LANDSIDE ACCESS MODERNIZATION PROGRAM

ITF-W_A Interim Ground Access (IGA) **Project # DA-5305A**

Package Transmitted For	Delivered Via	Tracking Number
CO-0008-PDG FULLY EXECUTED ITF-W A Interim Ground Access (IGA) Change Order #08 for CPCN No# 1007A, 1004A, 1003A, and 1011A 2019-06-21		CO-0008-PDG FULLY EXCUTED

CHANGE ORDER NO. 0008

APRIL 5 | NETFLIX
REGENCY
remove conduit and outlet box

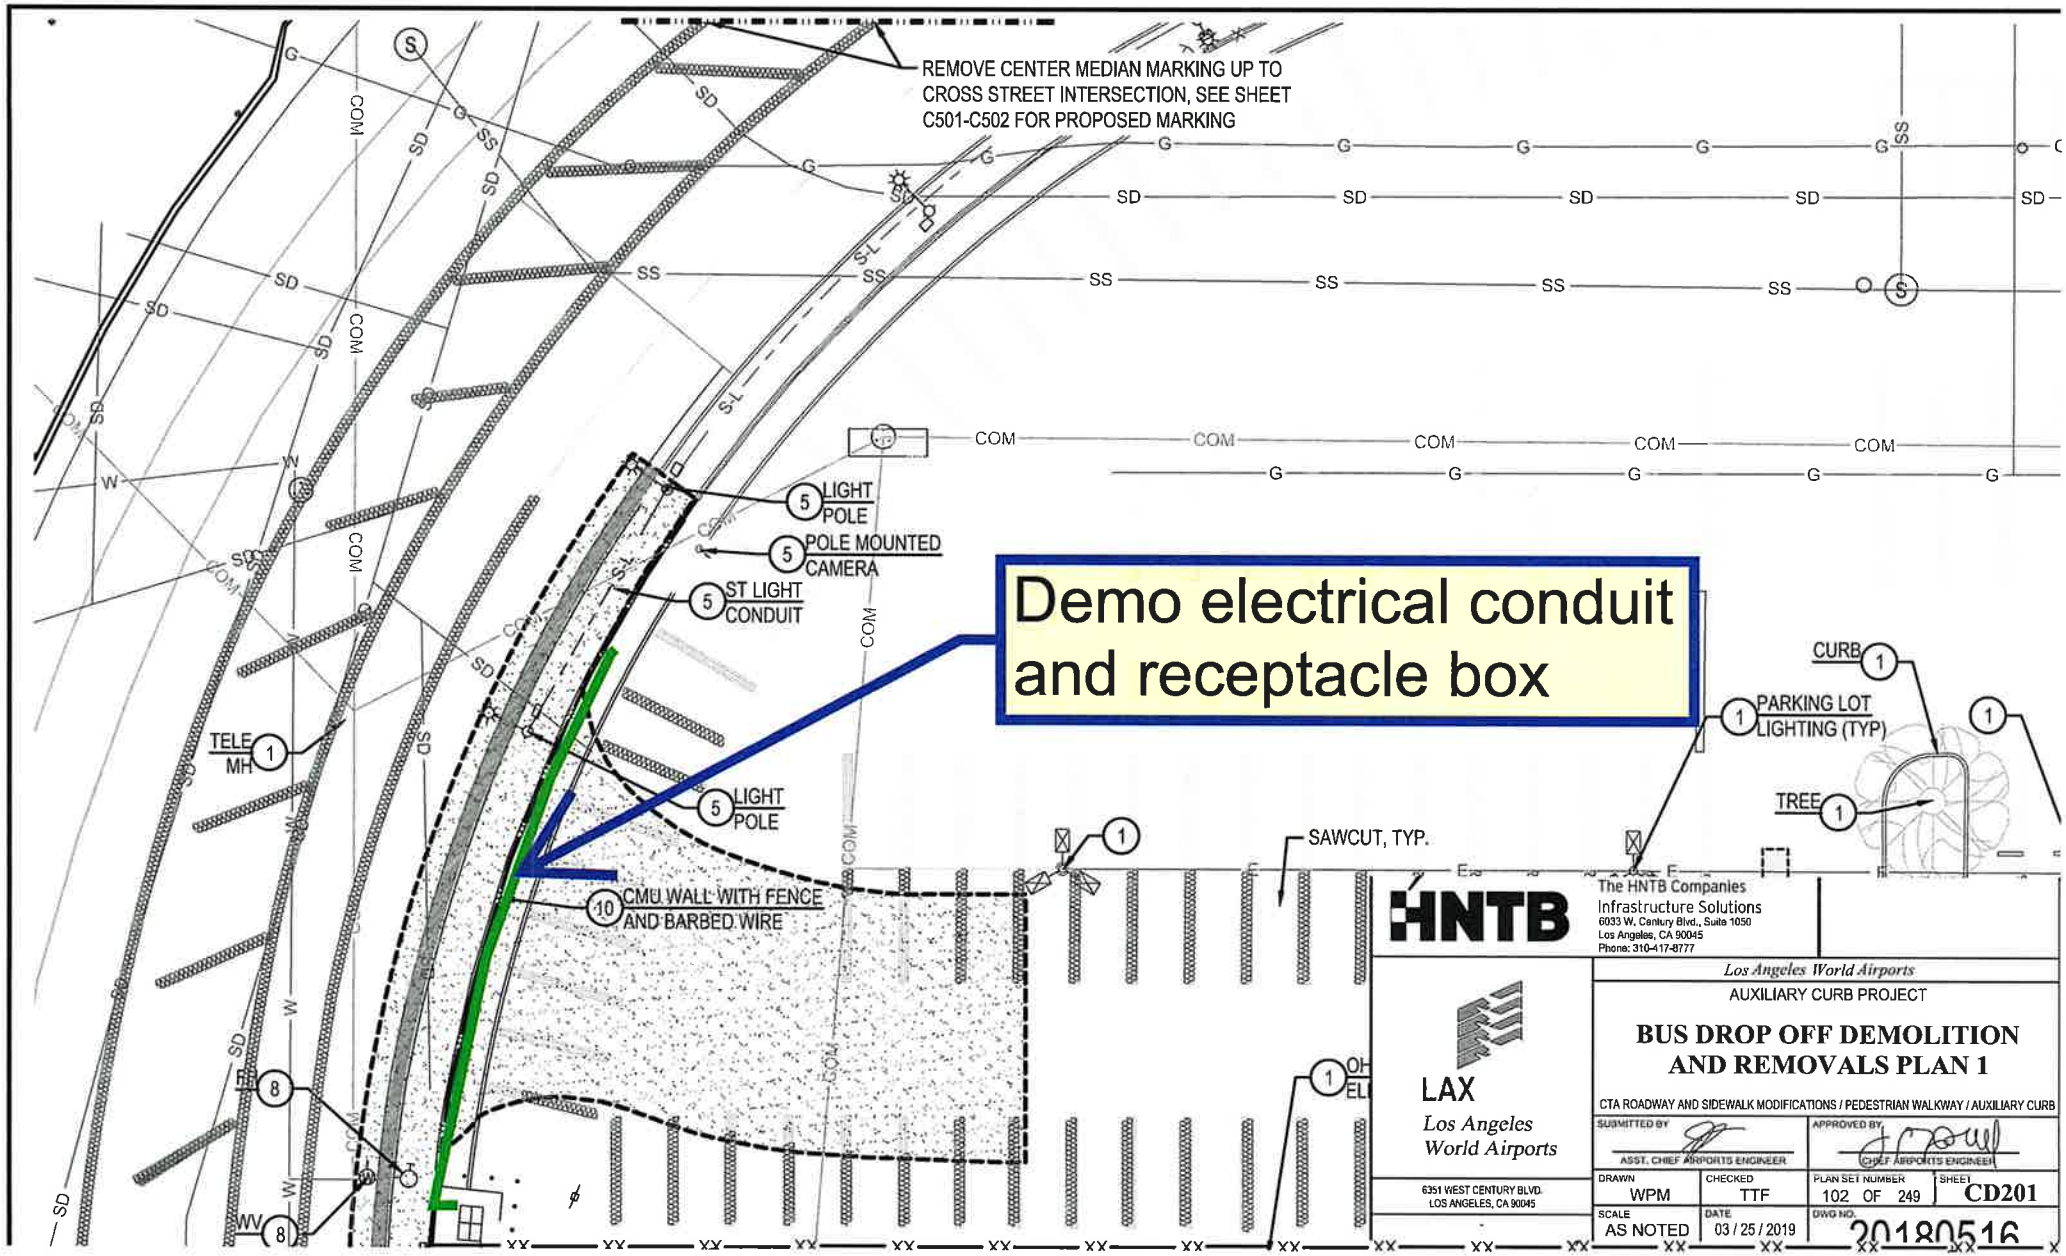
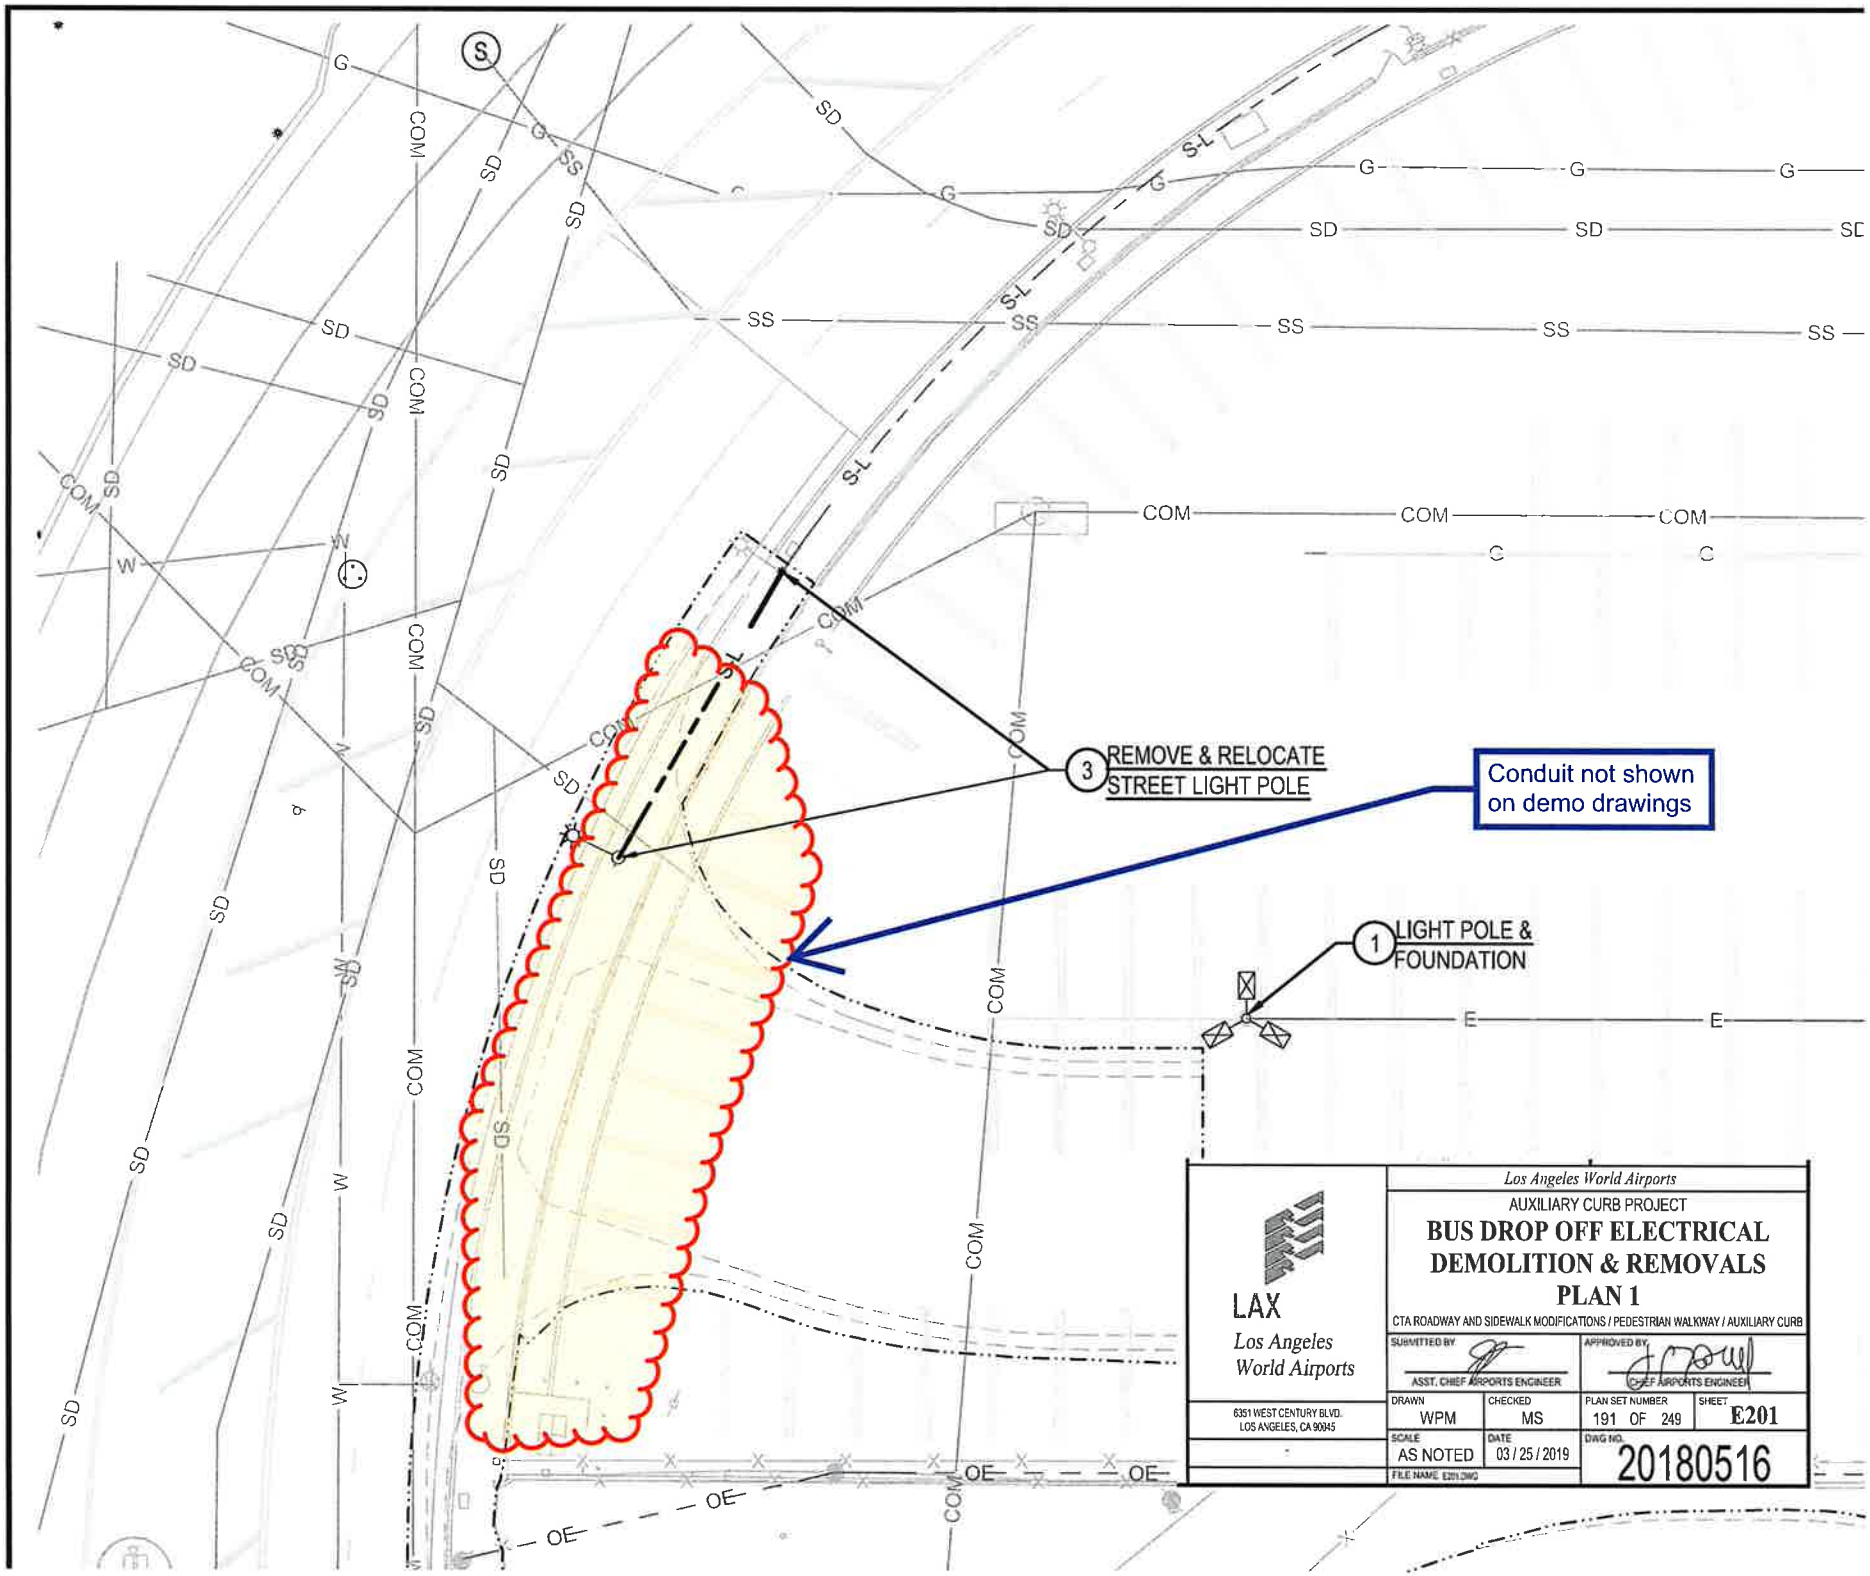
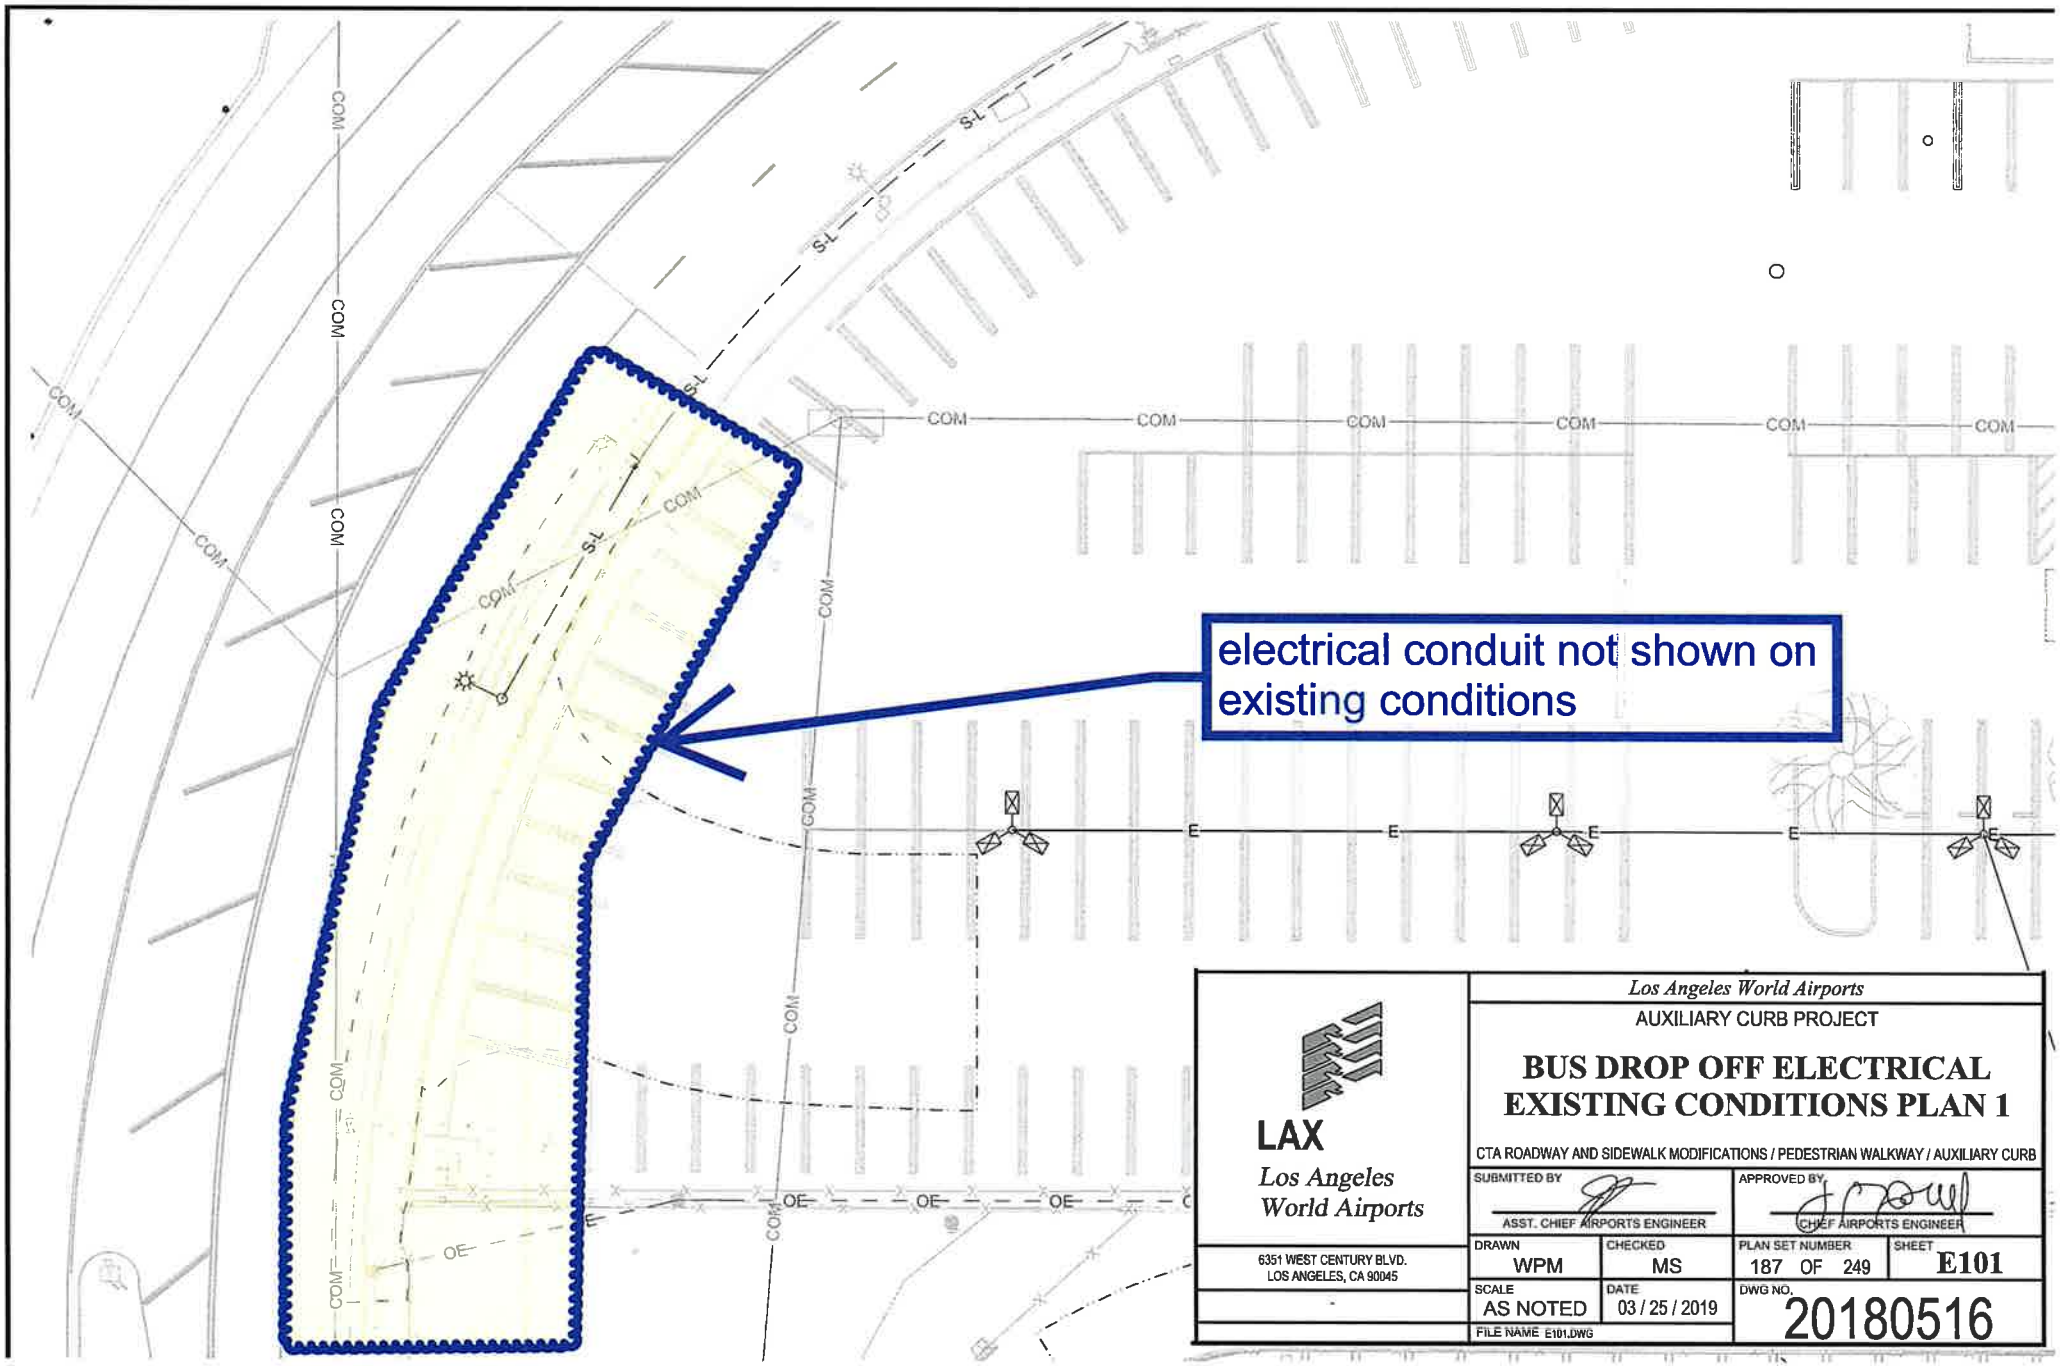
[4/9/2019 Swinerton Builders - Jones, Derrick]
Please confirm the following:
On Sheet CD201 there is an existing conduit which feeds an outlet, and is mounted on the CMU wall which is to be demolished for the new driveway approach. Demo Sheet CD201 and Elec. Demo Sheet E201 does not call for this conduit to be demolished. See attached marked up drawings. Please advise if the existing electrical conduit at electrical cabinet, and on the CMU-wall are to be removed/demoed.

NETFLIX
REGENCY
remove conduit and outlet box

electrical conduit not shown on existing conditions
COM
S-L
E
OE
LAX
Los Angeles World Airports
6351 WEST CENTURY BLVD.
LOS ANGELES, CA 90045
Los Angeles World Airports
AUXILIARY CURB PROJECT
BUS DROP OFF ELECTRICAL EXISTING CONDITIONS PLAN 1
CTA ROADWAY AND SIDEWALK MODIFICATIONS / PEDESTRIAN WALKWAY / AUXILIARY CURB
SUBMITTED BY
ASST. CHIEF AIRPORTS ENGINEER
APPROVED BY
CHIEF AIRPORTS ENGINEER
DRAWN WPM
CHECKED MS
PLAN SET NUMBER 187 OF 249
SHEET E101
SCALE AS NOTED
DATE 03 / 25 / 2019
DWG NO. 20180516
FILE NAME E101.DWG

Scope: Sheet CD201 calls for demo of the CMU wall but does not clarify direction for conduit mounted on the wall. Per direction from LAWA in RFI 0006 SB is directed to demo conduit. See attached backup documentation.

The contract adjustment required as a result of:
Added cost to demo existing conduit not shown on drawings E201. Conduit to be demolished per LAWA direction.
